**APPENDIX E.5: Minutes and Resolutions for New Items from Study Team by the Letter on  
October 1999**

**THE NORTH SINAI INTEGRATED RURAL DEVELOPMENT PROJECT (PHASE III)**

CONVEYANCE CANAL SYSTEM  
 BETWEEN THE END OF EL EL AND ZONE  
 UNTIL THE BEGINNING OF EL SIR AND EL KAWAR ZONE

**Figure V.3-1 Length of Suction Sump**

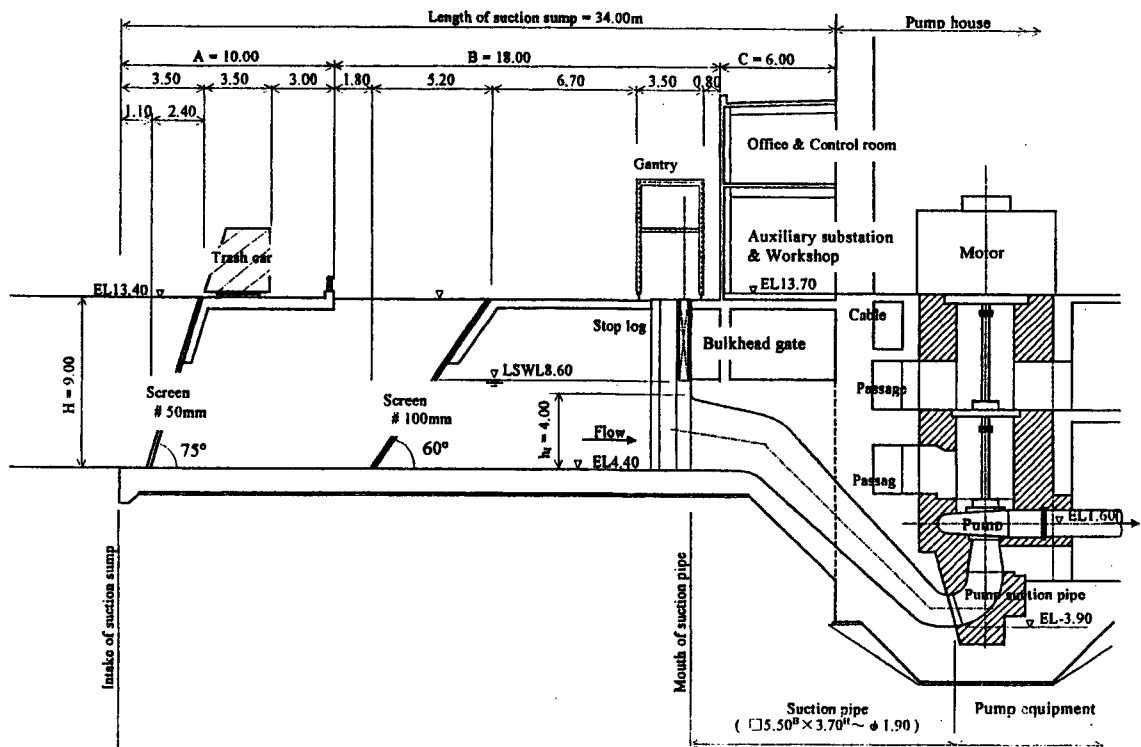
**Item V-03 : The study team proposes the revised length of the suction sump for enough maintenance space of the guard screen.**

**Resolution :** According to the Technical Meeting with MED held on 2<sup>nd</sup> October 1999, MED requested to revise the maintenance space of the guard screen. The conclusion of the study team is the space of 6.70m, because the distance (: 11.0m) between the guard screen and the building of pumping station is more than the length of the guard screen(: 10.4m).(Refer to Figure V.3-1)

Therefore, the length of suction sump shall be changed from 30.50m to 34.00m

Figure V.4-1 General Plan of No.7 Pumping Station

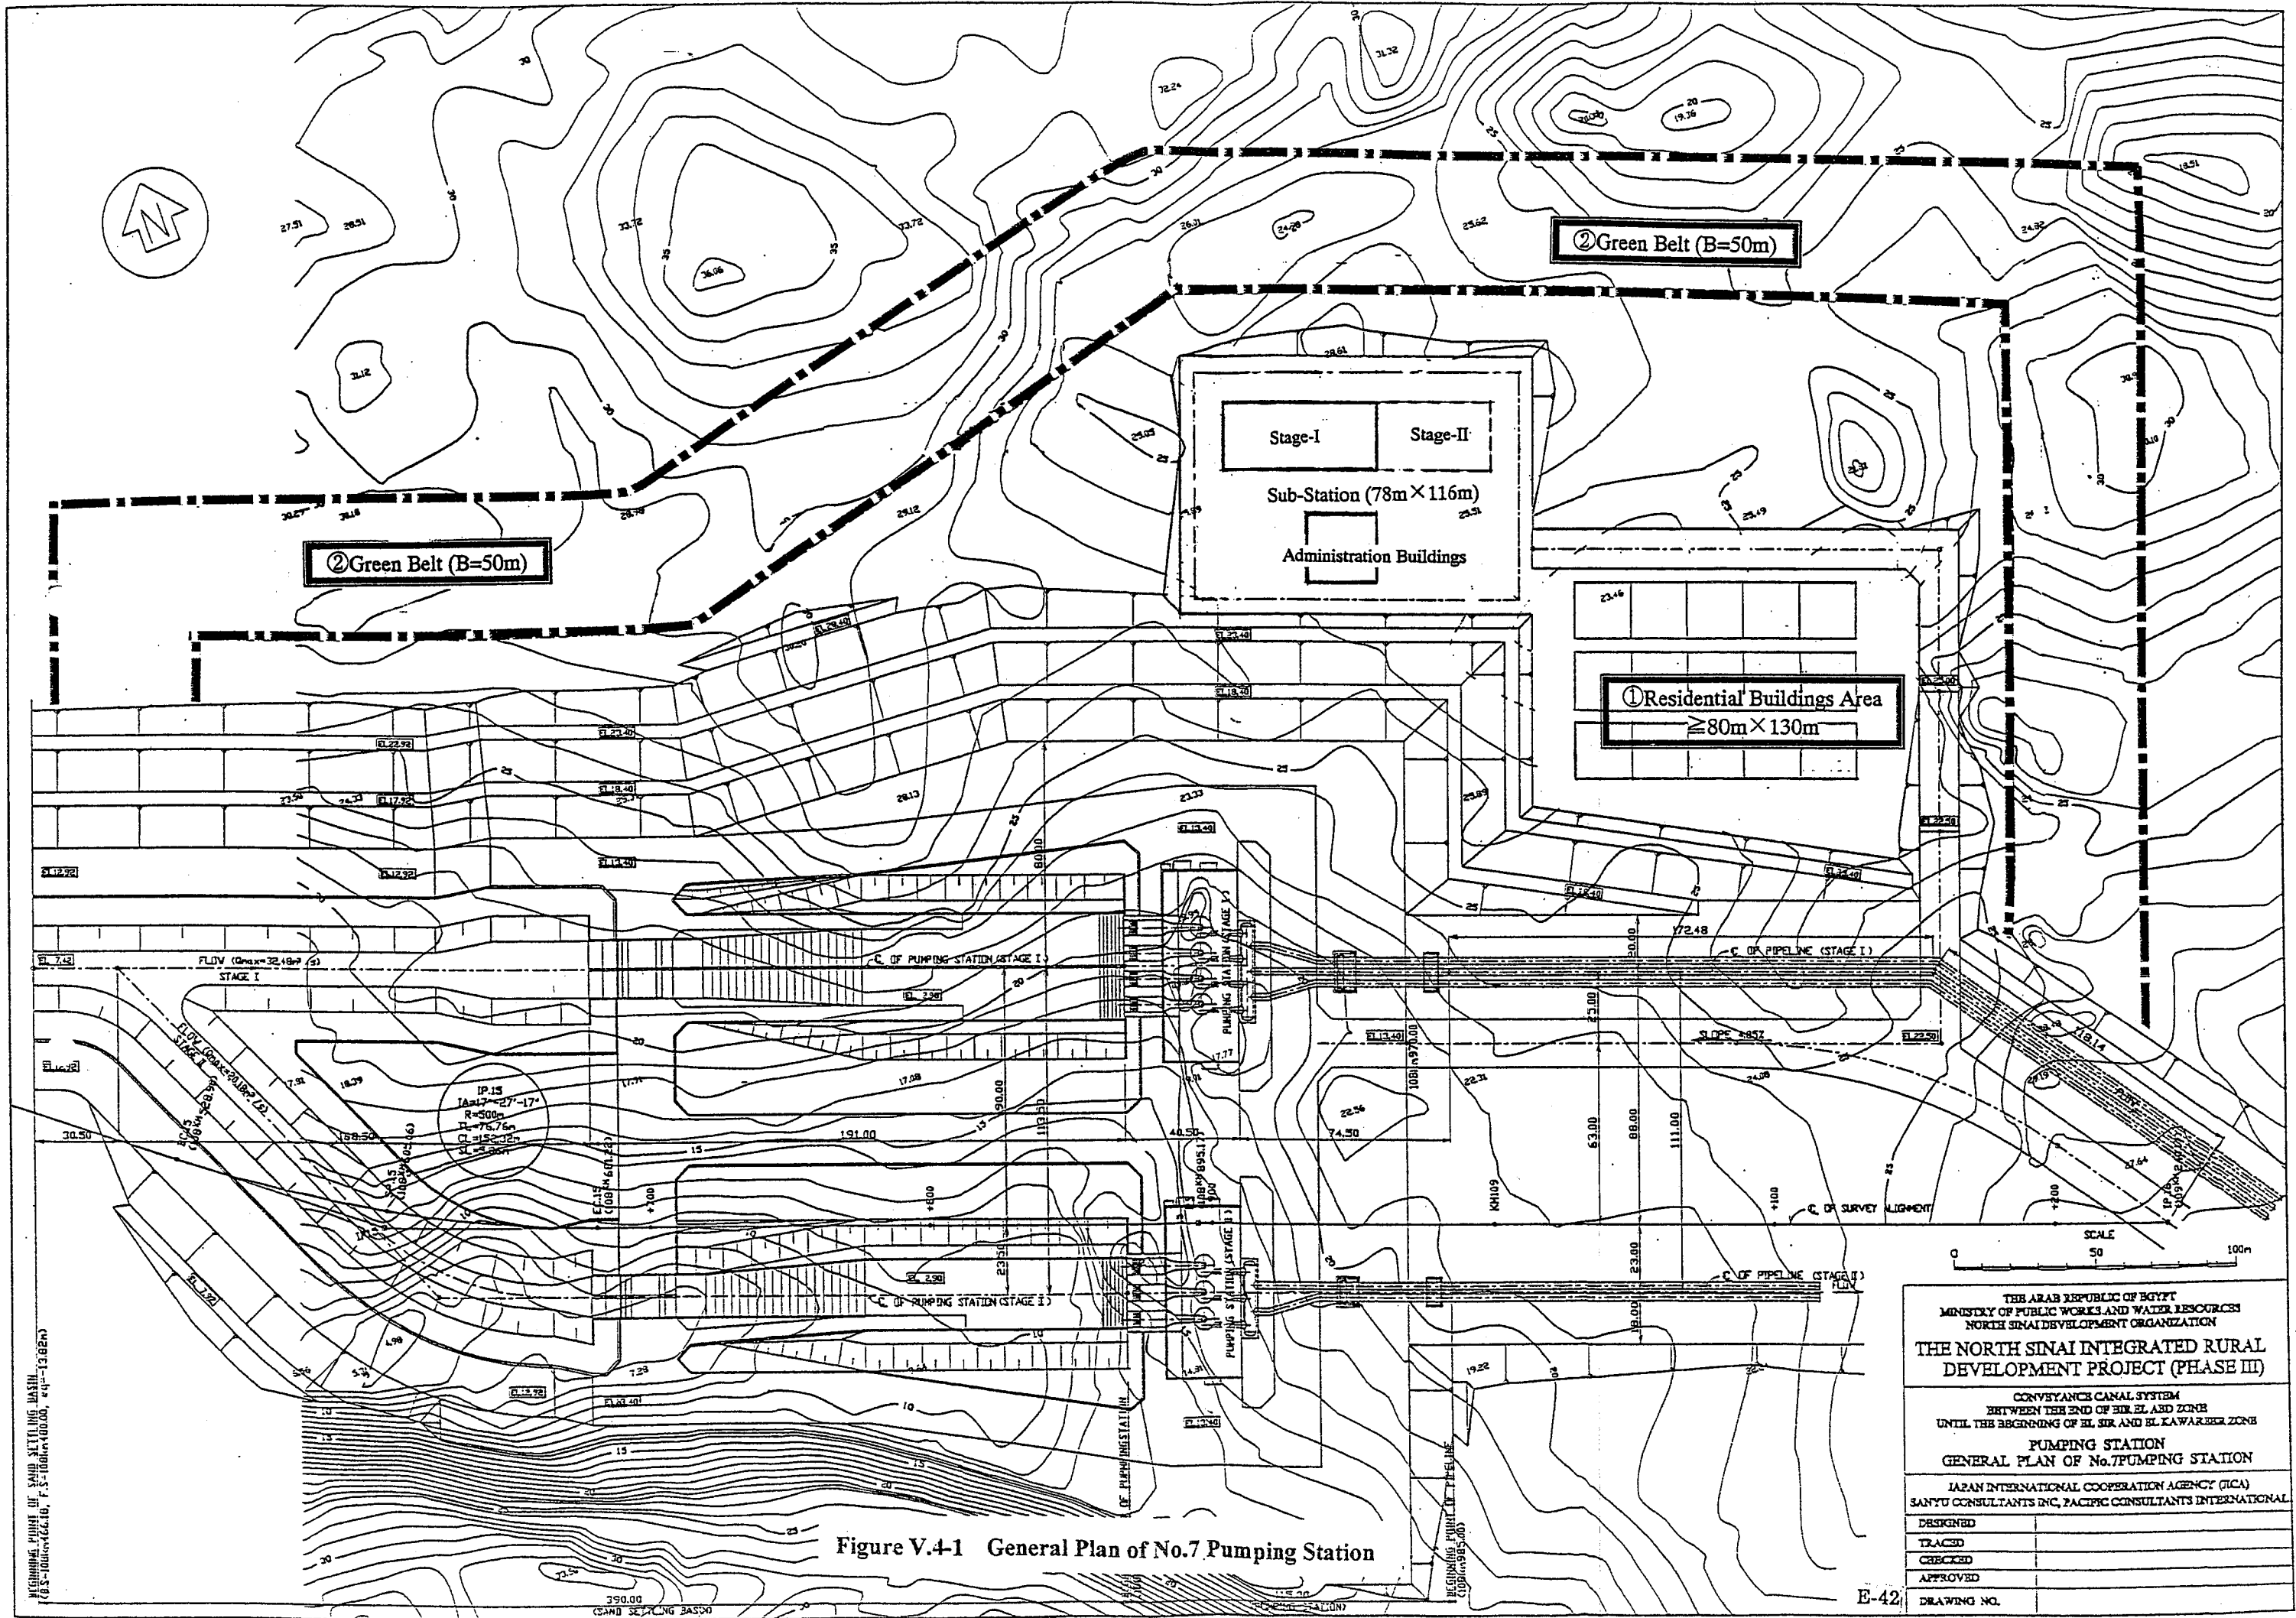
**Item V-04 : The study team proposes provision of green belt zone to protect against drift sand dune phenomenon at vicinity of the residential buildings area and main substation of the No.7 pumping station.**

The location of the main substation and residential buildings area is planned at the northeast of the No.7 pumping station area. According to the Feasibility Study Report, the residential buildings area has about 1.0 ha (80m x 130m) for 15 buildings.(Refer to Figure V.4-1)

Resolution : For protection against sand dunes, the study team proposes the green belt with 50m width on the northern boundary of No.7 pumping station.

**BOX CULVERT SECTION (CONVEYANCE CANAL)**

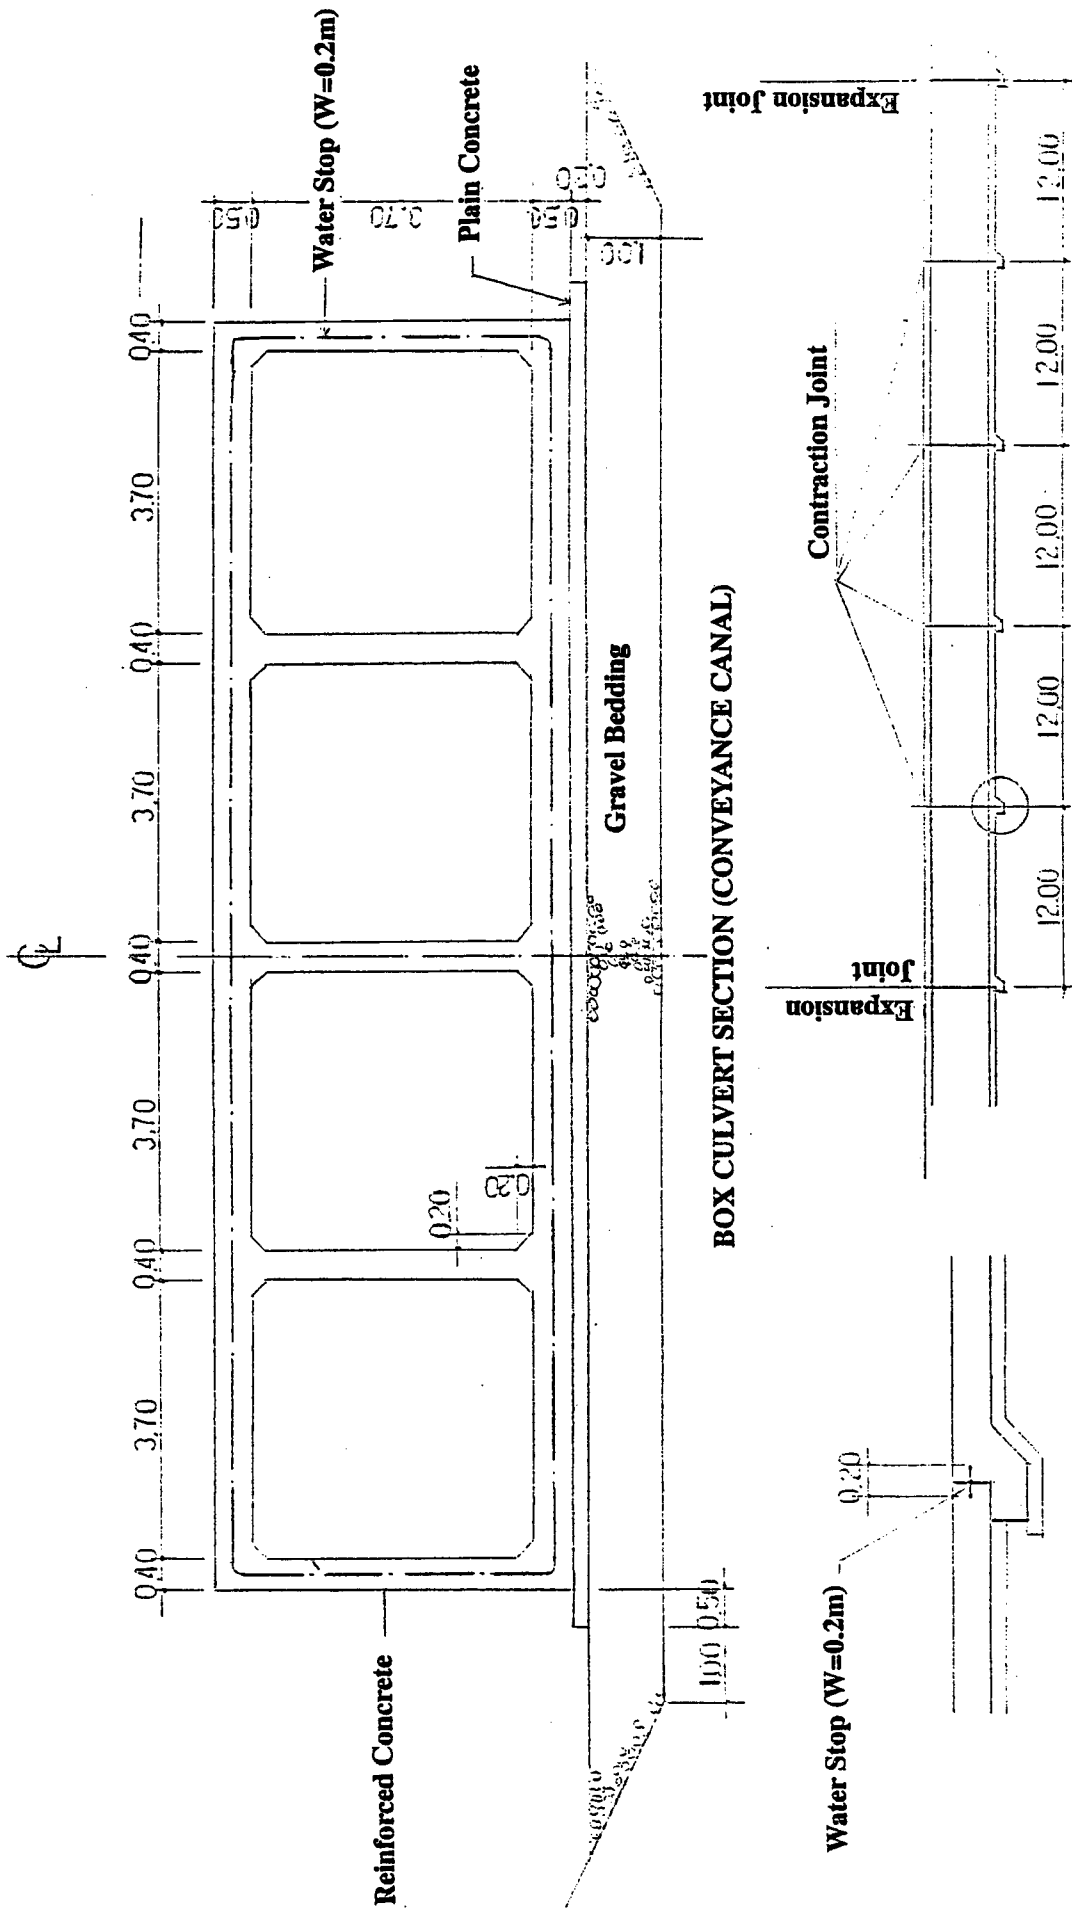
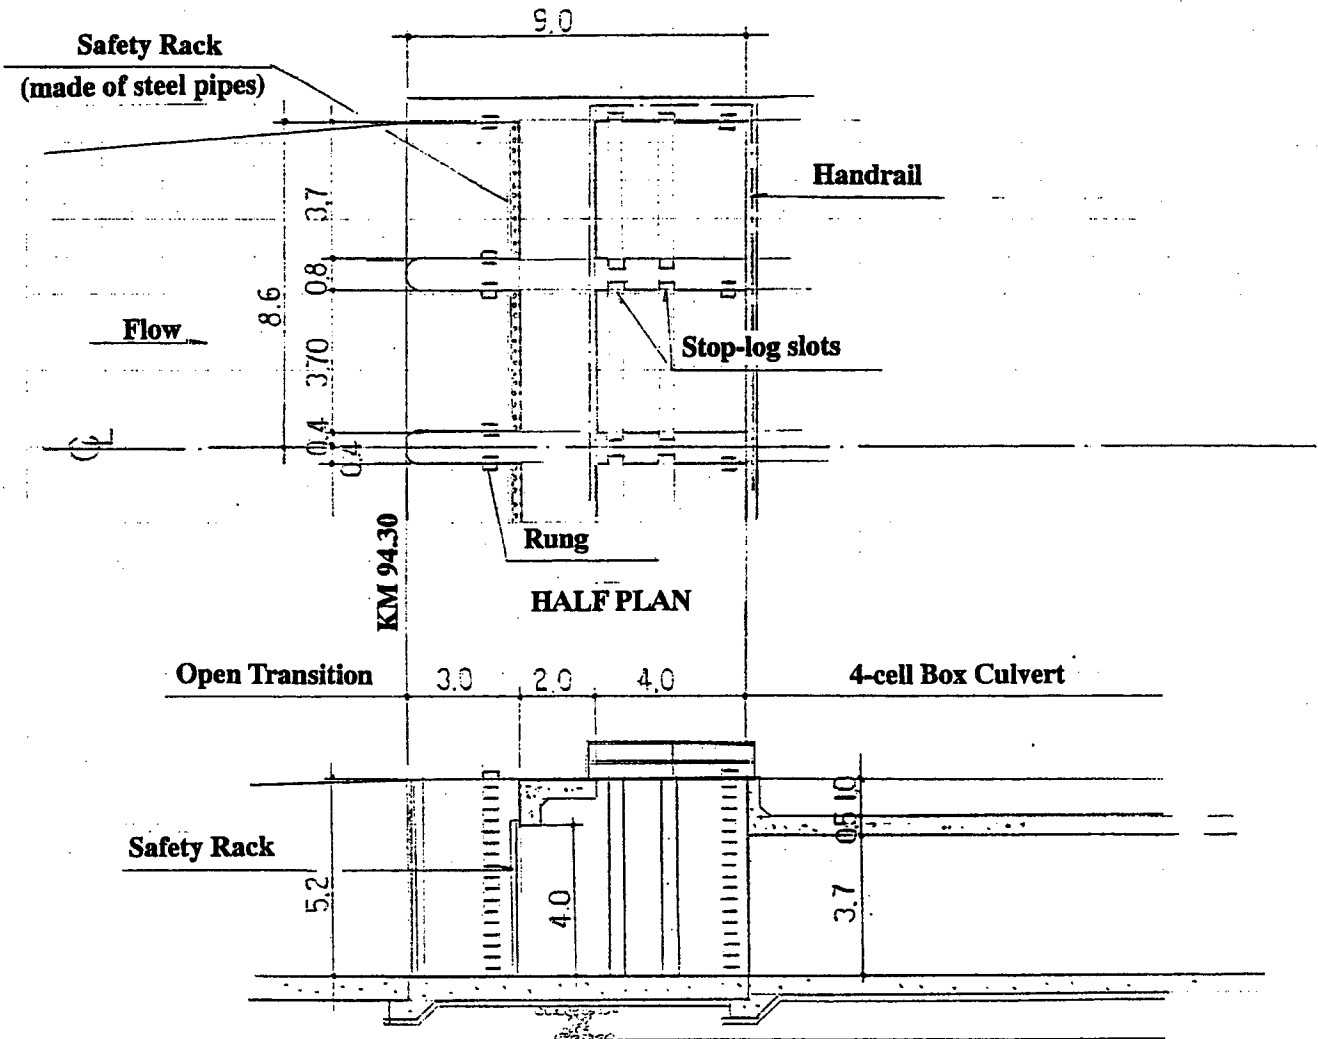
Items	Description															
1. Box Culvert	<p>a) Thickness of Bottom Slab Thickness of bottom slab of box culvert section is changed from 0.6m to 0.5m based on the detailed structural calculation. (Refer to Appendix-1)</p> <p>b) Water Stop Water stop of 20 cm wide will be used at both sections of expansion and contraction joints. (Refer to Appendix-1)</p> <p>c) Expansion Joint Expansion joint will be provided every 5 sections (Refer to Appendix-1)</p> <p>d) Inlet of Box Culvert Inlet of box culvert is as shown in Appendix-2.1. Safety racks made of steel pipe (0.3m spacing) will be installed.</p> <p>e) Safety device along openings Top of wall of opening structures is planned 1.0m higher than the ground elevation. Therefore, safety devices such as safety fence, handrail, etc. are not installed along the openings. (Refer to Appendix-2.2)</p>															
2. Spillway System	<p>a) The profile of spillway and spillway outlet channel is shown in Appendix-3.</p> <p>b) The spillway structures are shown in Appendix-4.1 – 4.5.</p> <p>c) In the Interim Report (2), the bridge has been planned at 780m downstream from the beginning point of the spillway and spillway outlet channel. However, it is changed to box culvert section. (Refer to Appendix-5)</p> <p>d) The bottom width of spillway outlet channel is changed from 15m to 10m. (Refer to Appendix-5)</p> <p>e) Expansion joint will be provided every 3 sections. (Refer to Appendix-5)</p> <p>f) The chute and stilling basin structures are shown in Appendix-6.</p> <p>g) Asphalt paved road will be only provided from the beginning point to the existing road. (Refer to Appendix-7)</p> <p>h) The width of O/M road along the spillway outlet channel will be changed from 17m (shown in Interim Report (2)) to 12m. (Refer to Appendix-8)</p>															
3. Necessary Information	<p>a) Location and size of NSDO's office and residence for construction.</p>
